2022 Portable Loudspeaker System Project REQUEST FOR PROPOSALS (RFP) ADDENDUM NO. ONE November 17, 2022

This Addendum forms a part of the documents and modifies the Request for Proposal dated November 3, 2022. The Proposer is responsible for determination of proposal requirements affected by Addendum items.

Side Stage Configuration with 8pc (x2) Mains and 6pc (x2) Side Fill on 20' lifts

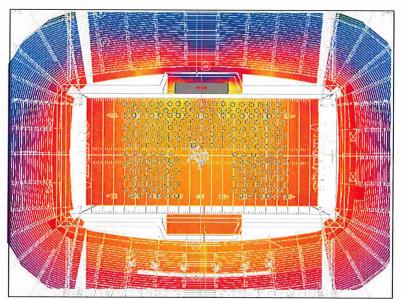
6. Project Diagrams may be found on the following pages.
